**Comanche Peak Nuclear Power Plant, Units 3 & 4
COL Application**

**Part 3,
Environmental Report
Update Tracking Report**

Revision 5

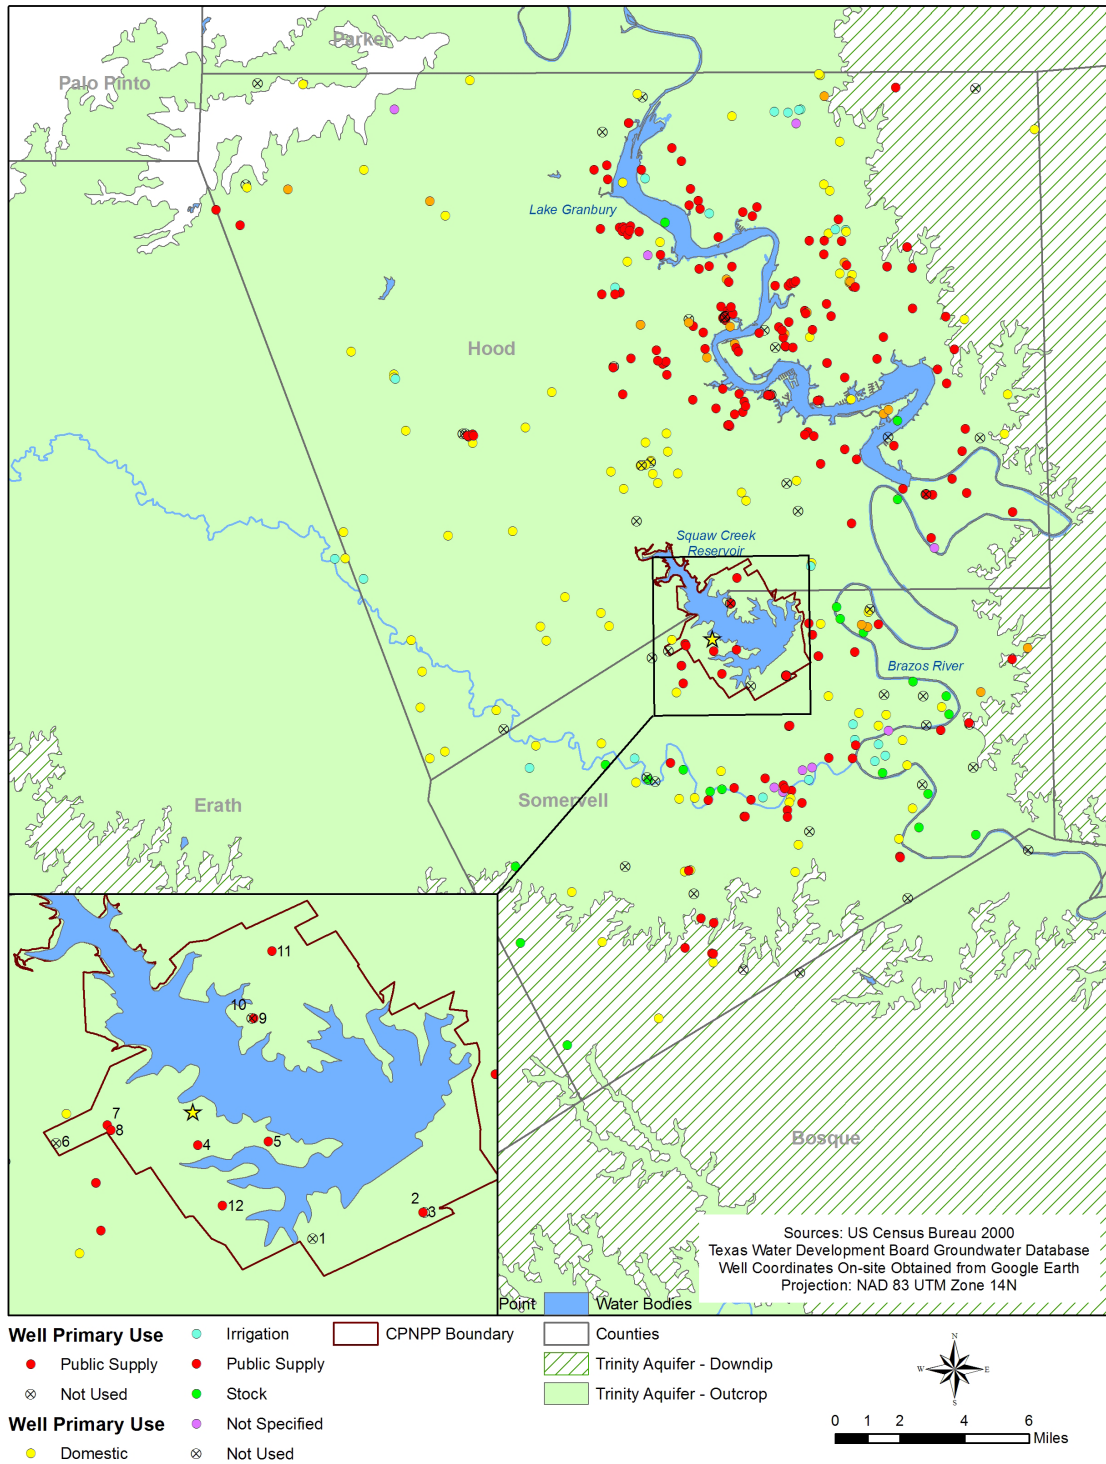
Northing	Easting	
UNIT3:	613759 <u>3574606</u>	3574606 <u>613759</u>	CTS-00716
UNIT4:	613453 <u>3574559</u>	3574559 <u>613453</u>	CTS-00716

The center point of the CPNPP Units 3 and 4 site is located at ~~613606~~3574584N and ~~3574584~~613606E. CTS-00716
